San Jacinto River Waste Pits Superfund Site

Comments
of
International Paper Company
and
McGinnes Industrial Maintenance Corporation
on
U.S. Environmental Protection Agency Region
6
Proposed Remedial Action Plan

January 12, 2017

Figure 1
2011-2016 Maintenance Areas
San Jacinto Waste Pits Superfund Site
IP/MIMC's Comments to Proposed Plan

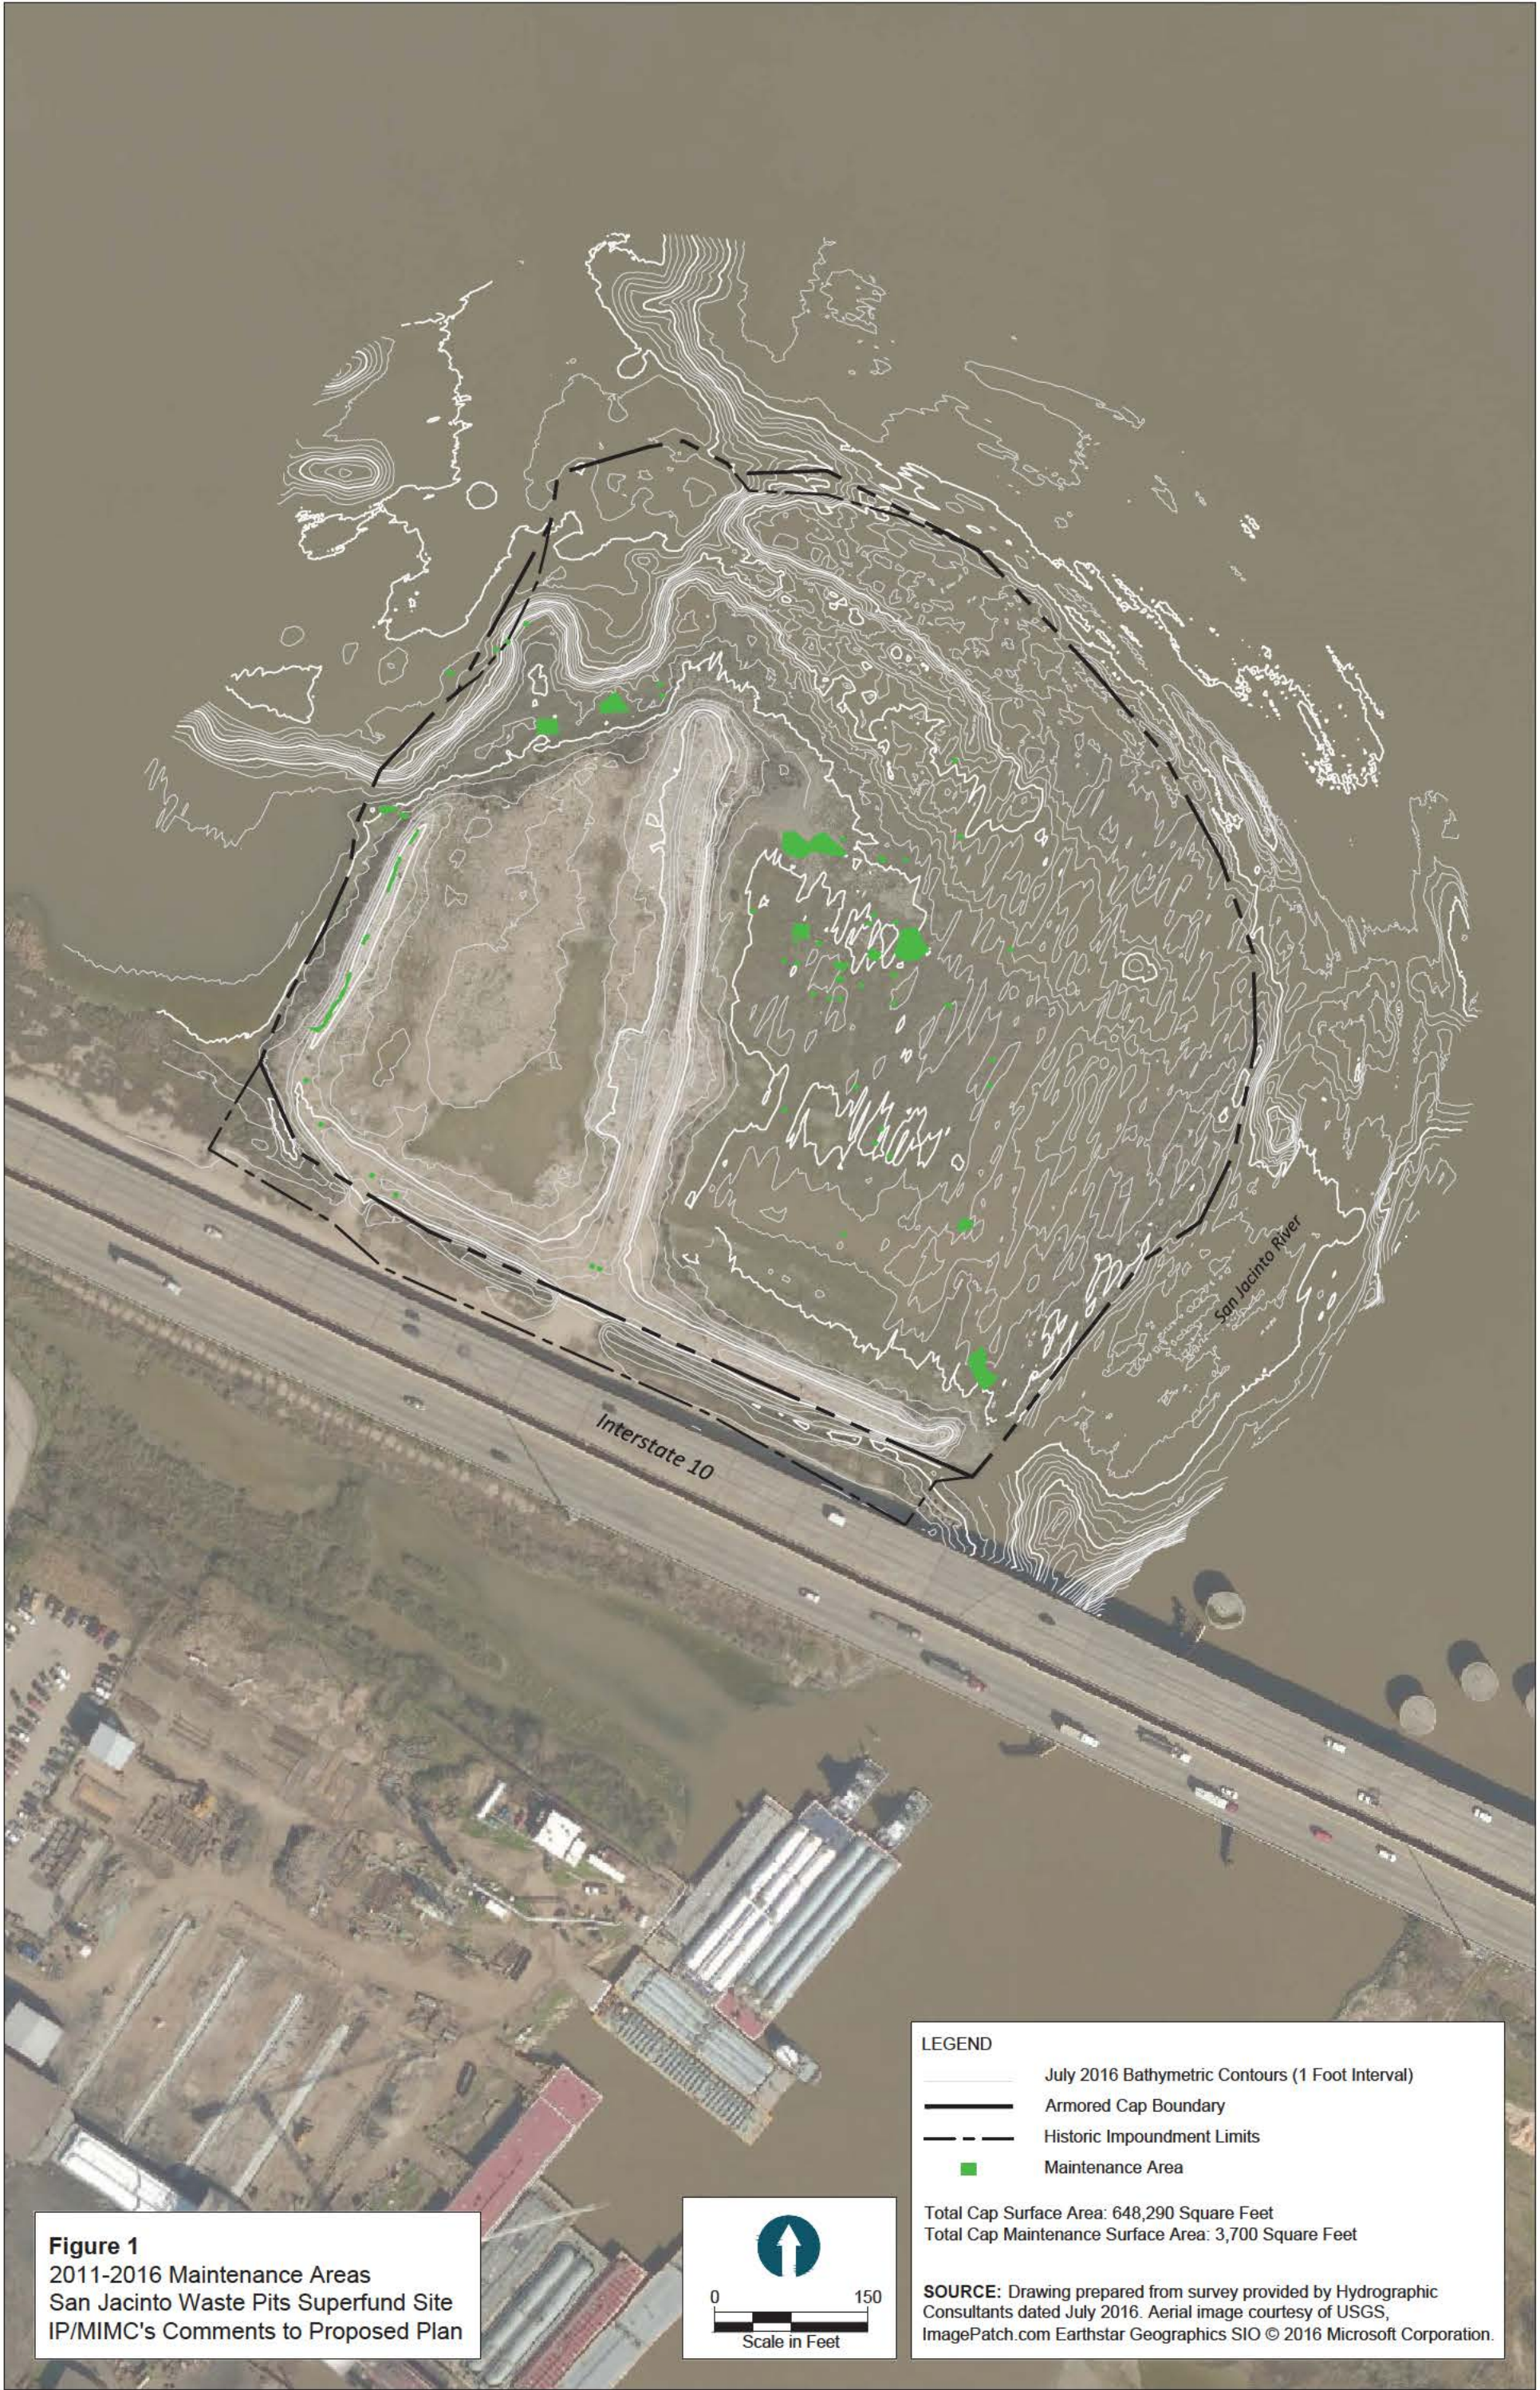
Maintenance of the armored cap has been routine and anticipated, and the Proposed Plan’s summary of “repairs” to the existing armored cap overstates the level of the required maintenance. In fact, the TCRA Operations, Monitoring, and Maintenance (OMM) Plan for the Northern Impoundments, approved by Region 6, contemplated potential maintenance of up to 5% of the cap surface—yet all maintenance activities combined at the existing armored cap have involved approximately 0.57% of the total cap.

The existing armored cap has now successfully undergone a total of more than five years of operation and maintenance (O&M). During this time period, occasions have arisen for which the need for maintenance in small areas of the cap have been identified, with Respondents promptly performing the maintenance pursuant to Region 6-approved maintenance plans and with no loss of waste material from beneath the cap.³⁷ The areas in which maintenance has been performed collectively represent 0.57% of the total surface area of the existing armored cap.

Figure 2: Armor Rock Size Comparison

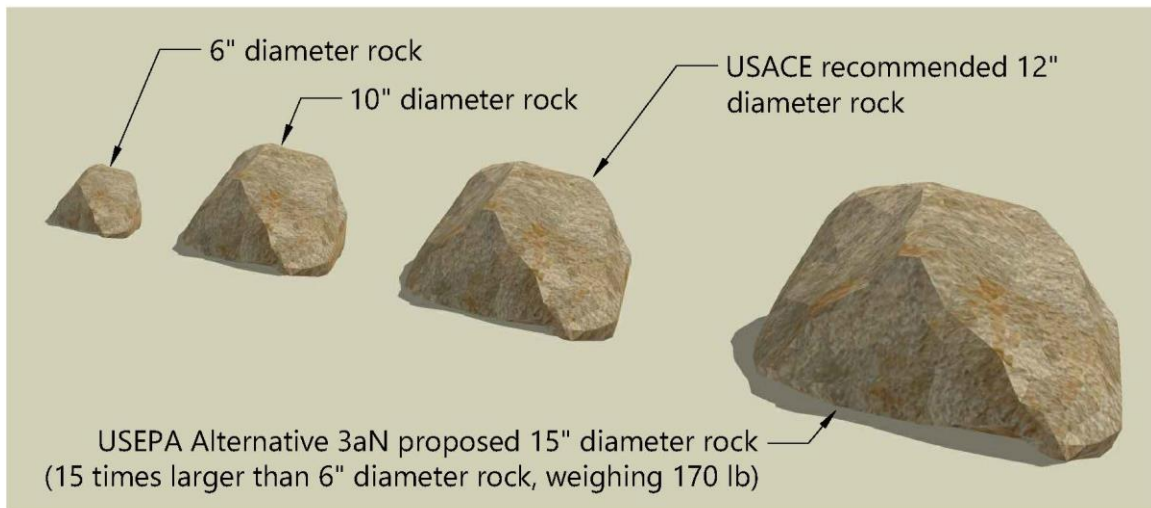
The enhancements to the existing armored cap as part of Alternative 3aN were developed by USACE. They include adding two feet of much larger rock to most of the cap, and adjusting slopes to increase their long-term stability.¹³ This step should reduce the need for future maintenance. According to USACE, it also will be protective against erosion during future extreme events of the kind that Region 6 asserts raise questions as to the cap's long-term effectiveness.

The increase in rock size will have the most dramatic impact in areas of the current cap (such as the location of the December 2015 maintenance event) with three and six inch rock. The 15-inch rock required by Alternative 3aN will therefore result in an increased “factor of safety” in the cap’s design and performance, well beyond EPA and USACE’s design requirements. The current cap armor stone size is based on the hydrodynamic modeling performed for a full range of extreme events as described in Appendix B: Hydrodynamic Cap Modeling to the initial draft of the FS and also to the Draft Final Interim FS.¹¹⁵ The cap armor stone size was computed using the Maynard method, from USEPA ARCS Guidance – Appendix A: Armor Layer Design.¹¹⁶ Applying the Maynard method, the minimum safety factor for riprap design is 1.1. The factor of safety for the TCRA design was 1.3 and was 1.5 for Alternative 3N in the draft FS and Draft Final Interim FS. . By using armor stone with a D50 = 15 inches for Alternative 3aN, the safety factor would be increased to a minimum of two to more than seven depending on location.

Figure 3
 Proposed Plan Removal in the Dry and Wet Areas Using
 an Approximate -3 Foot NAVD88 Elevation
 IP/MIMC January 12, 2017 Comments to Proposed Plan
 San Jacinto River Waste Pits Superfund Site

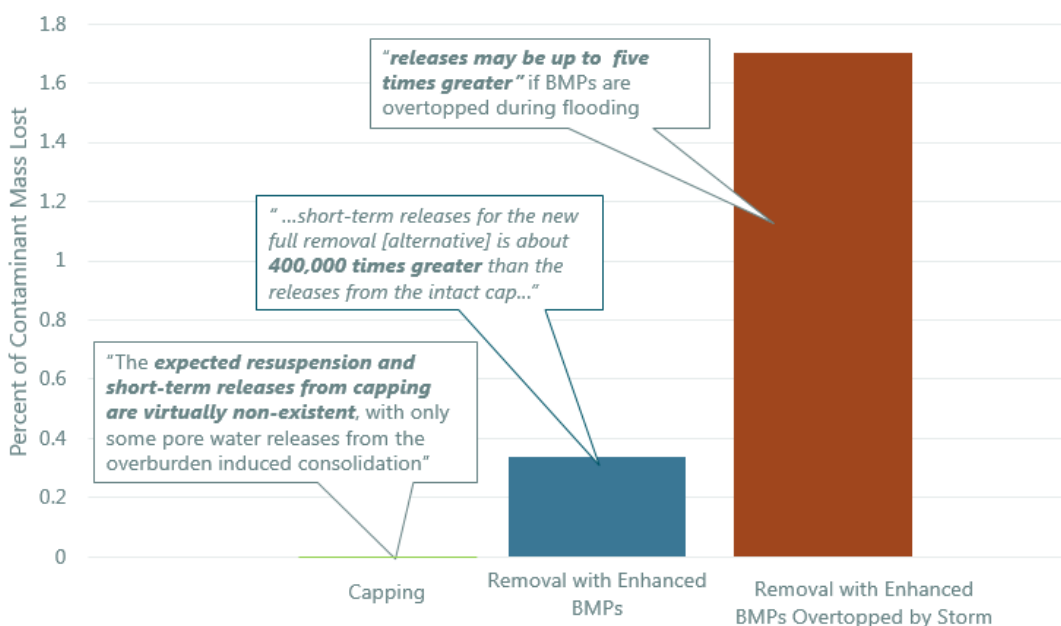
The Proposed Plan and Final Interim FS acknowledge that one-fourth of the waste (located in deeper areas of the Northern Impoundments) will be dredged “in the wet.”¹⁹² The USACE Report and the Final Interim FS both indicate that these deeper areas would likely require the use of silt curtains, or a combination of silt curtains and sheet piles, as part of any removal action (even with enhanced BMPs), because of the technical impracticability of using other BMPs in those deeper water areas.¹⁹³ Figure 3 depicts areas of the armored cap (in the Northwestern Area and the Eastern Cell) in which, because water levels exceed -3 feet NAV, the

Figure 5: May 2016 Flood in San Jacinto River.

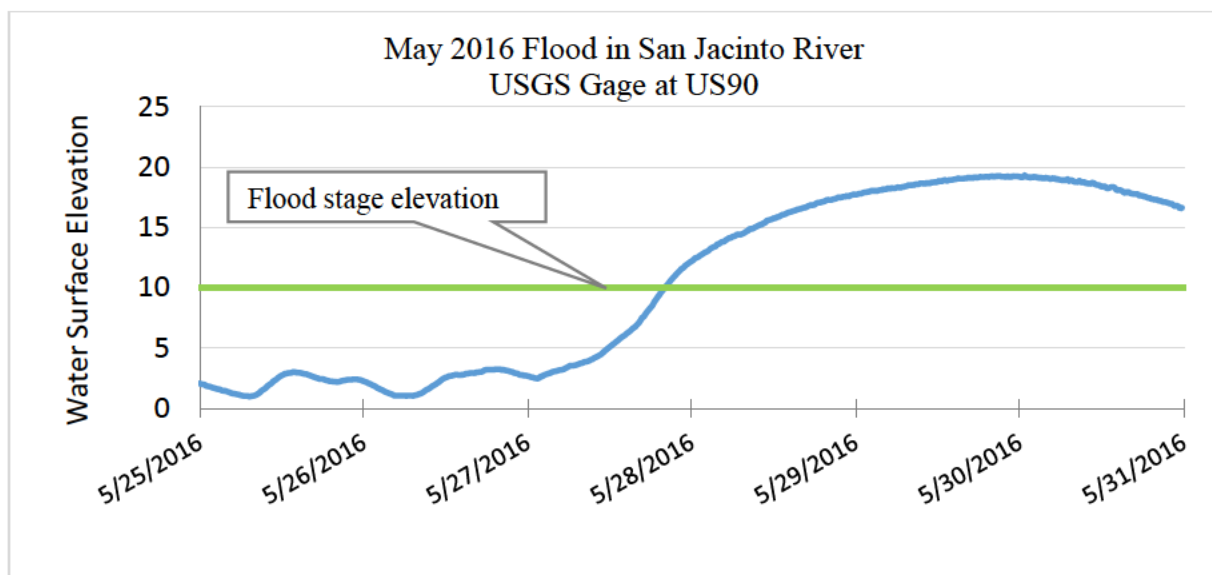
The magnitude of the two flood events (mentioned above) that occurred in the San Jacinto River in the spring of 2016 highlight the potential risks. The April 2016 flood was triggered by historic rainfall of more than 17 inches in a single day—an event that caught many local residents off guard. As shown in Figure 5, the water level increased by more than ten feet in a single day in the San Jacinto River during the May 2016 flood.¹⁹⁰

If a “dry” remediation were under way at the Northern Impoundments during either of these floods, it would have been virtually impossible to prevent the loss of material beyond the work area. It would have been equally difficult to respond to such a loss considering that the flooding prevented land access following the April flood.¹⁹¹

Figure 6:
Industrial Facilities in the Vicinity of the San Jacinto River and Houston Ship Channel (2004)
IP/MIMC January 12, 2017 Comments to Proposed Plan

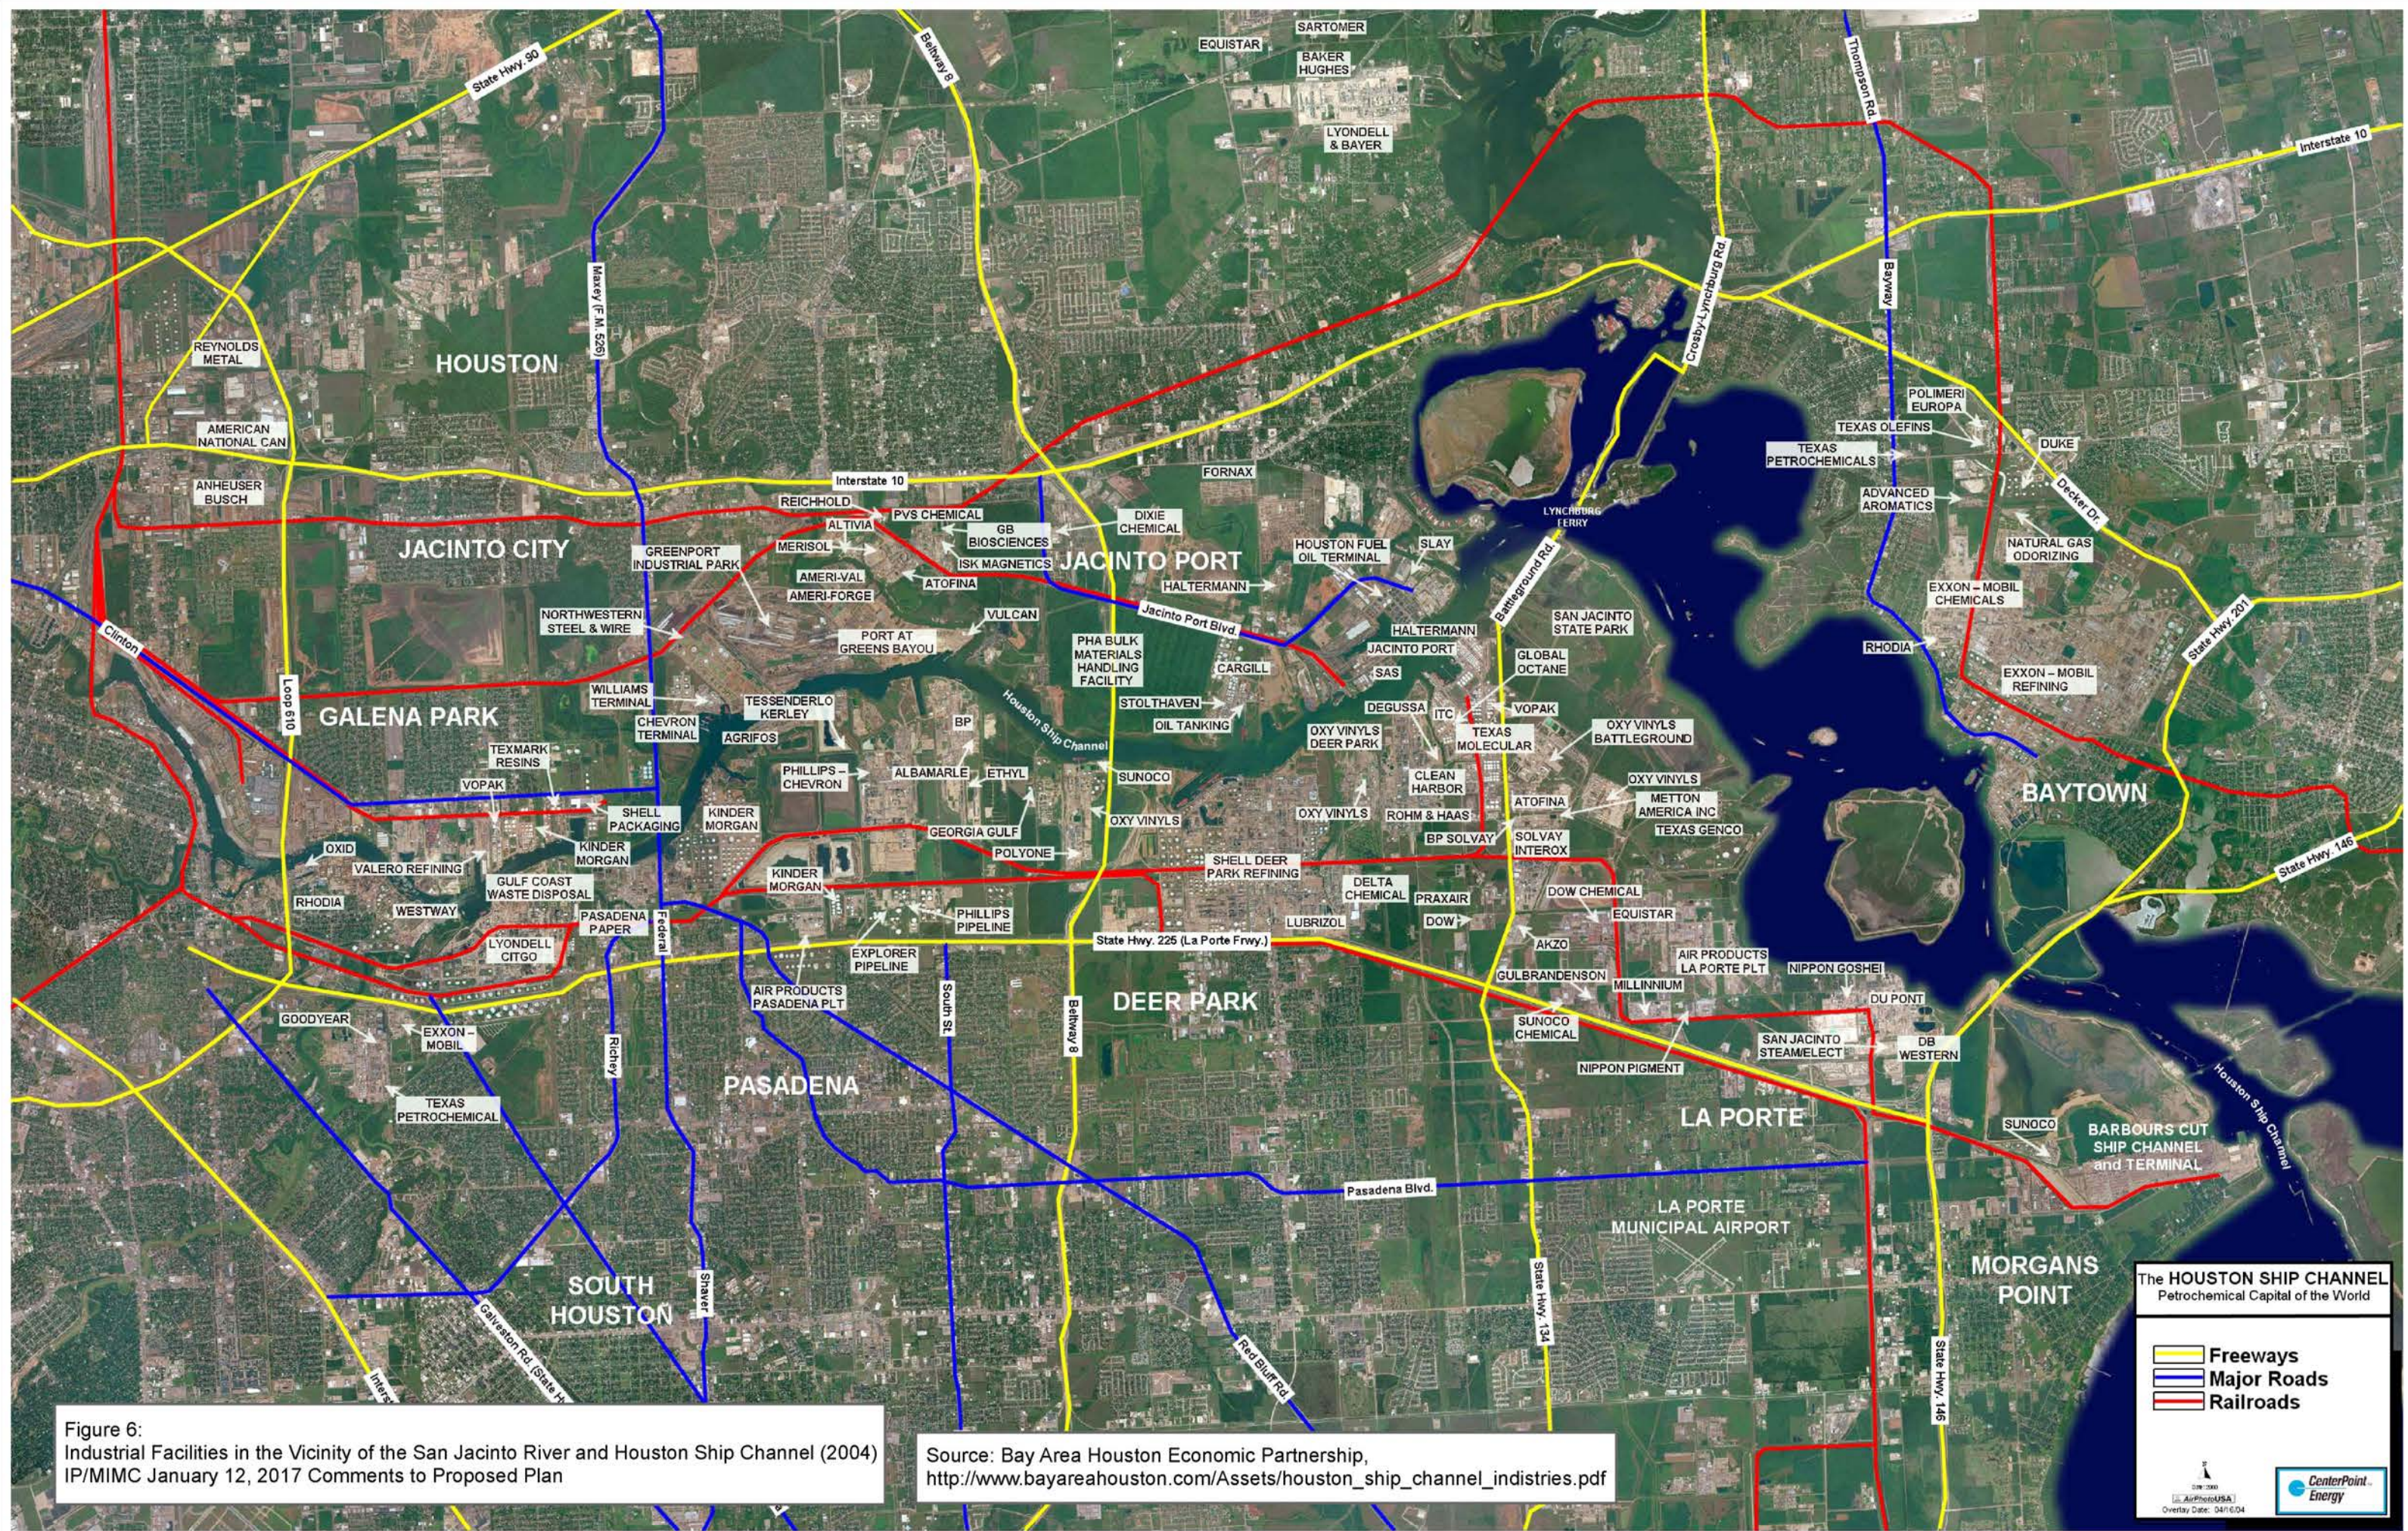
If Region 6 selects its preferred remedy largely on the basis of the possibility of future channel migration, that would suggest that every other chemical plant, manufacturing facility, or hazardous waste storage location along the San Jacinto River and Houston Ship Channel could be held to this standard as well. This speculative threshold would call into question current chemical and waste handling and disposal activities at those locations, and indeed throughout the United States since CERCLA is a national program. Figure 6 is a 2004 map prepared by the Bay Area Houston Economic Partnership that depicts some of these facilities in the vicinity of the Site. This figure, which refers to the Houston Ship Channel as the "Petrochemical Capital of the World," starkly illustrates the heavy concentration of industrial facilities along the channel and the San Jacinto River that could be impacted by the future channel migration Region 6 speculates could occur.

Contrary to Region 6's foundational assumption that the wastes south of I-10 could mobilize, facts demonstrate that the Southern Impoundment has been stable, is likely to continue to be stable, and is not subject to the depth of erosion that would be required to mobilize buried materials in the future. Moreover, if there could be a "catastrophic" release in a flood, that raises questions about the current permitting for hazardous substances used and stored by businesses operating on the peninsula south of I-10, as well as elsewhere along the river and in the Houston Ship Channel (Figure 6).
